Technical Briefing Note

Our Reference: 24675.115526

RFI Response – Gunyah Park Dairy

YURUNGA GUNYAH PARK - DA RESPONSE

SITE PLAN
1:4000

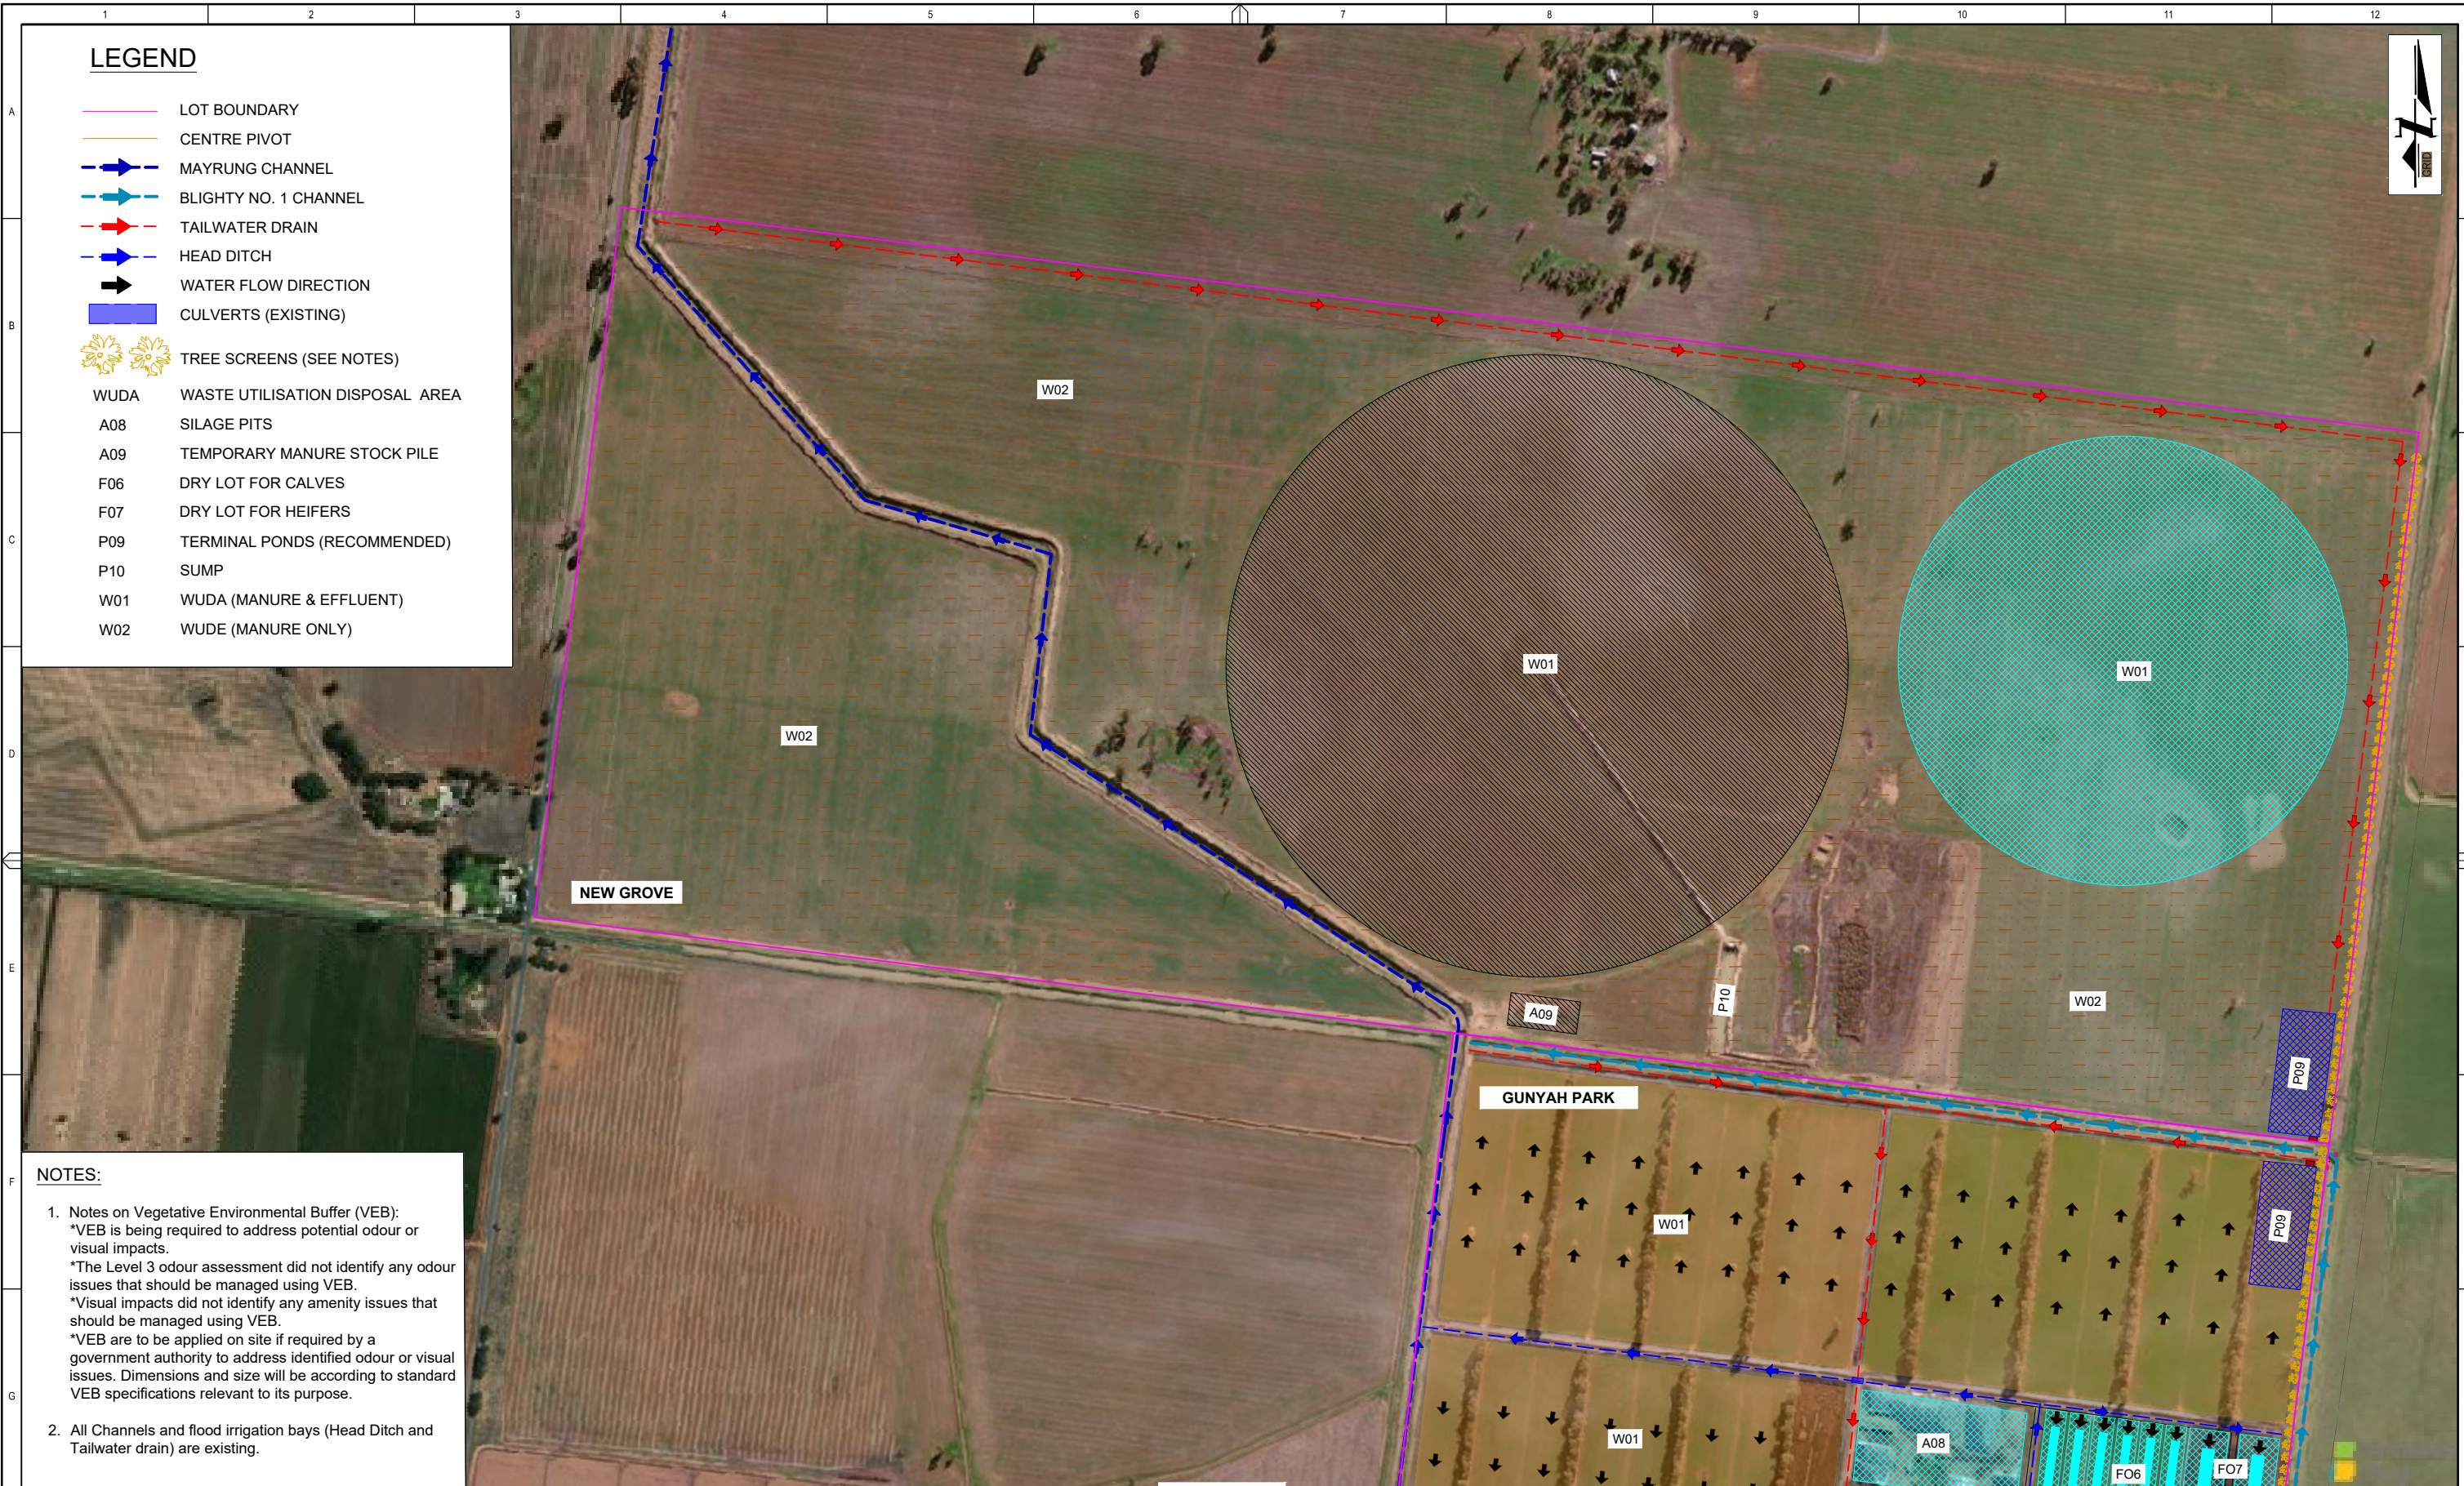
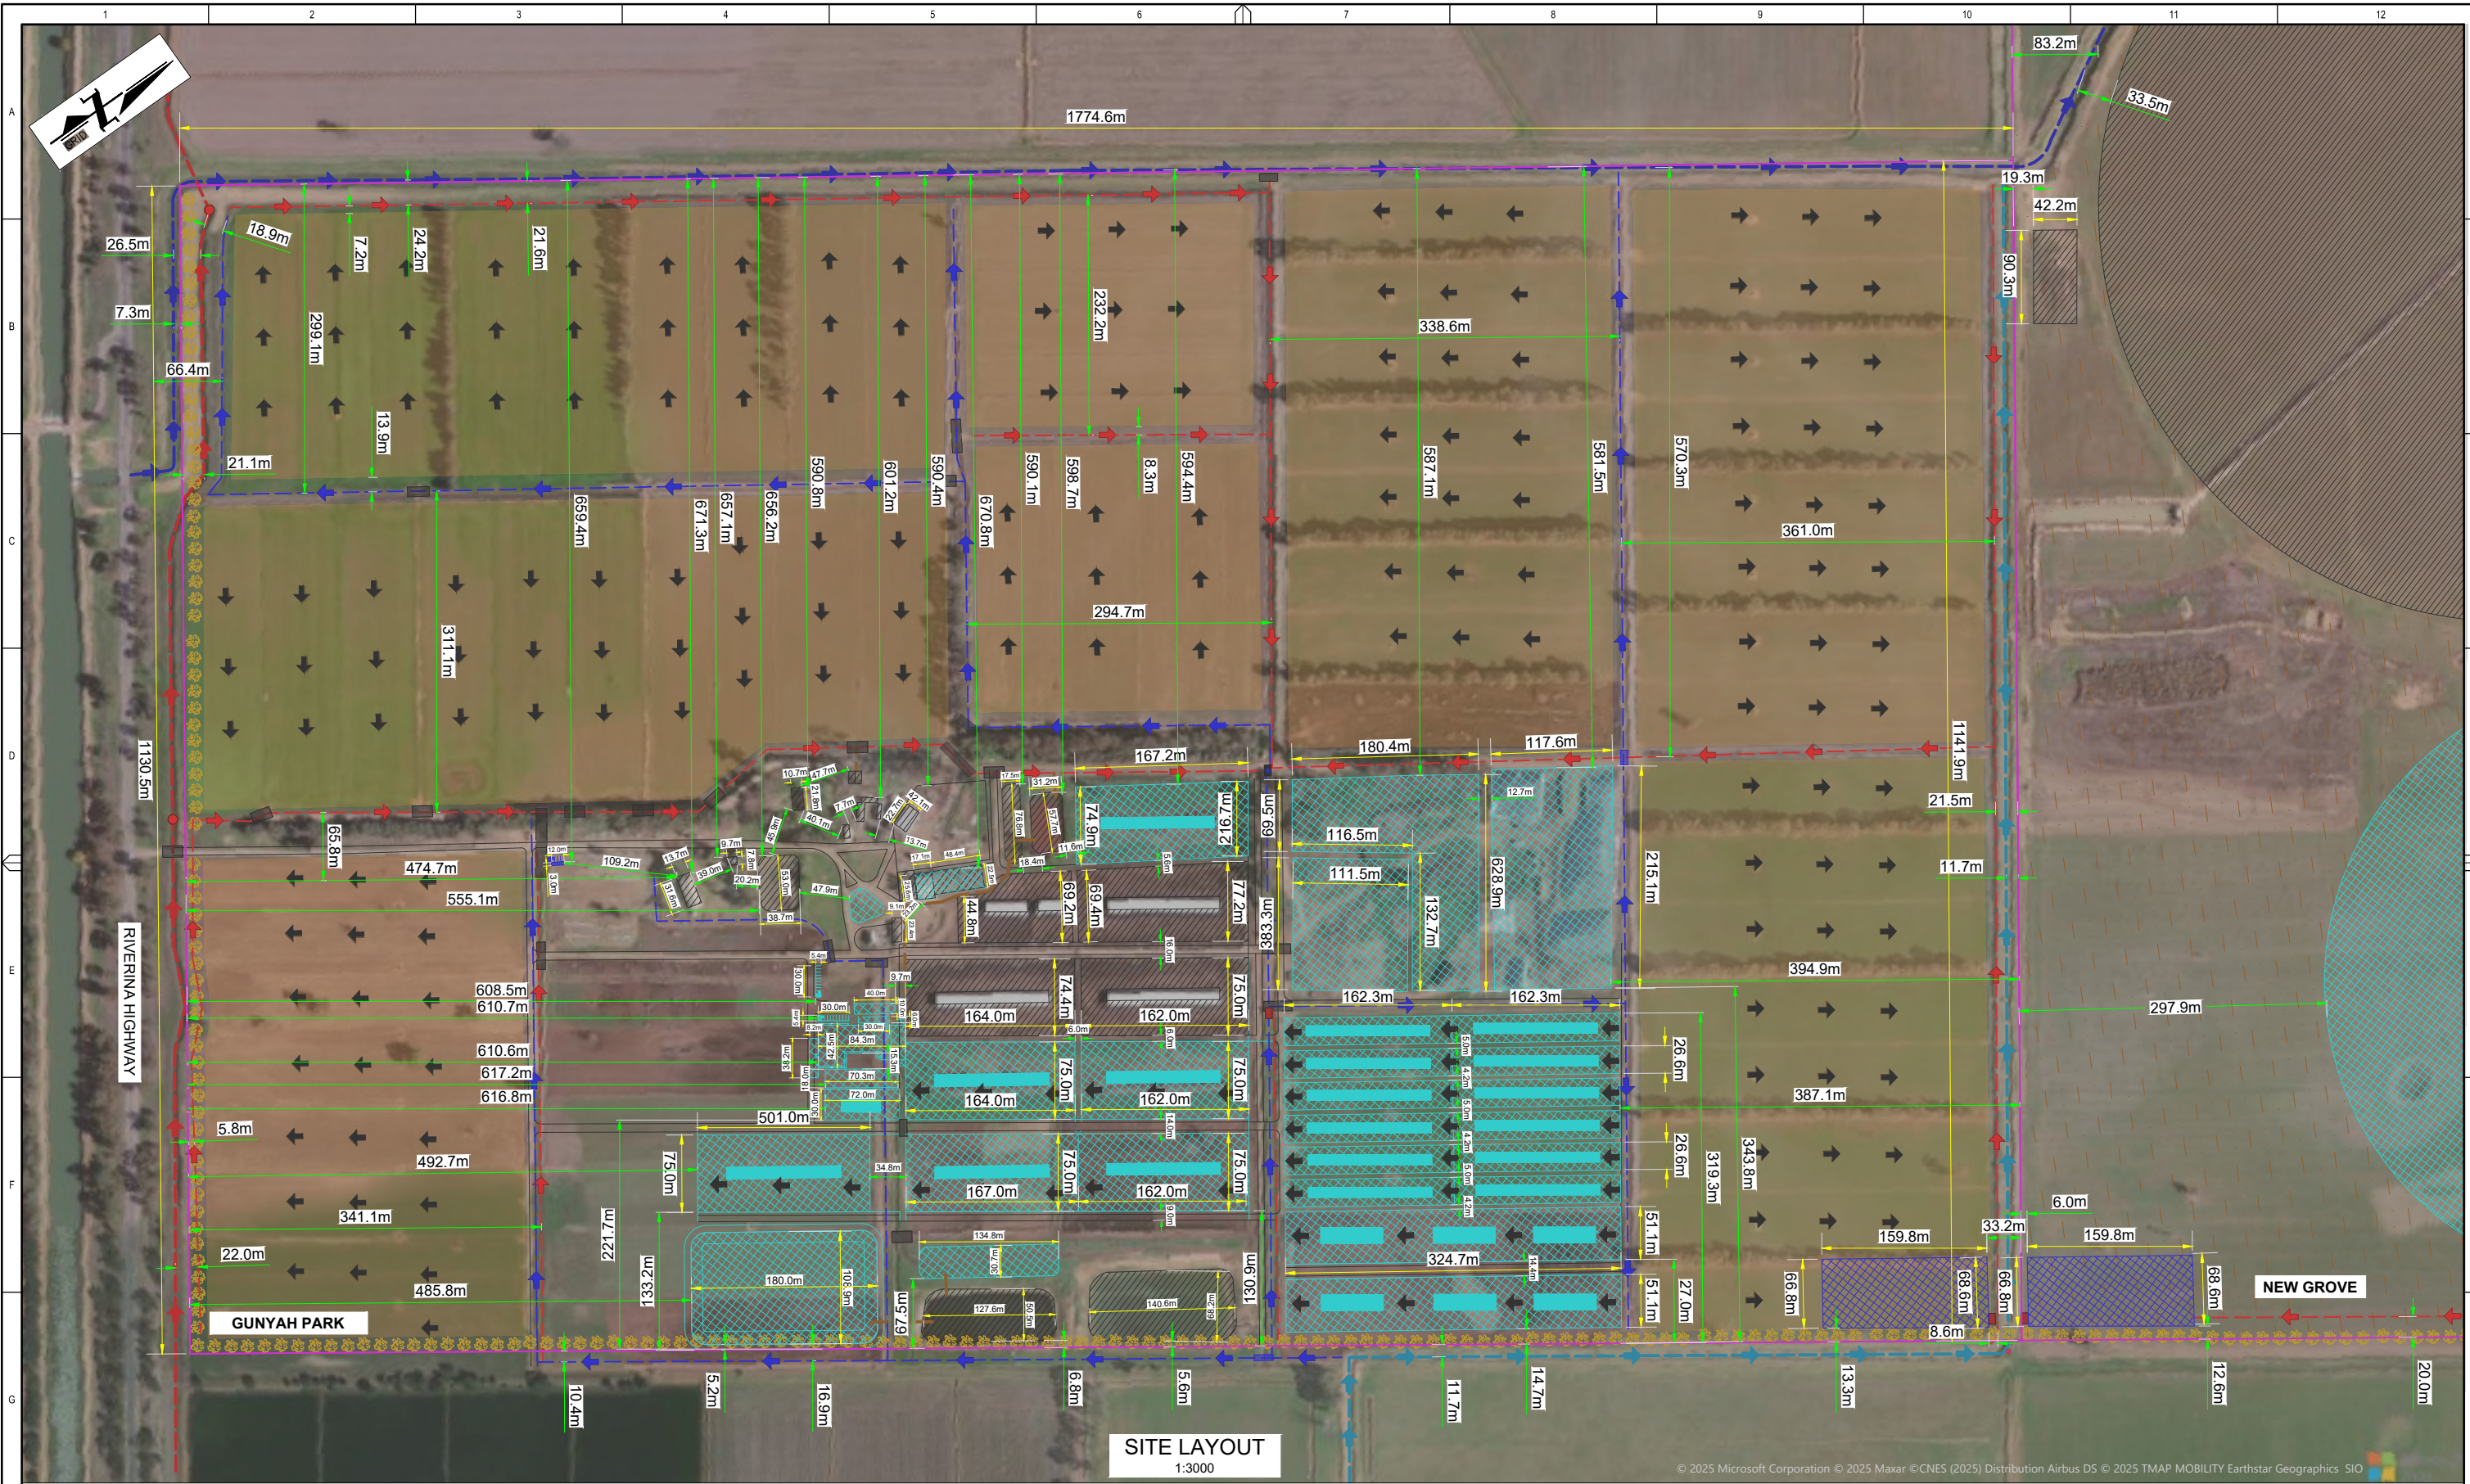
The current Plans do not provide separation/buffer distances, setbacks from lot boundaries, having regard for the proposed structures, waste utilisation irrigation areas, existing channel infrastructure, adjoining buildings/structures, dimensions/size of vegetation buffers and the like.

No plans have been provided of the following, as listed on the Site Plan Layout: Husbandry/Veterinary Facility, Plans of the Main Site Office, Workers Amenities, Plan of the Washdown Facility (and associated

In order to properly address this information request, the following changes to the site layout have been applied;

- The dairy parlour has had a positional change of about 50 m to the south for better herd management during milking. The milking centre is now connected to the dry lots via animal travel lanes.
- The new wash down facility was relocated to meet design requirements.

An amended overall site layout and additional set of plans are provided to support the Development Application and are included as Appendix B. This drawing package will replace *Appendix E Proposed Development* of the EIS Report (Reference: 24675.112831.0).
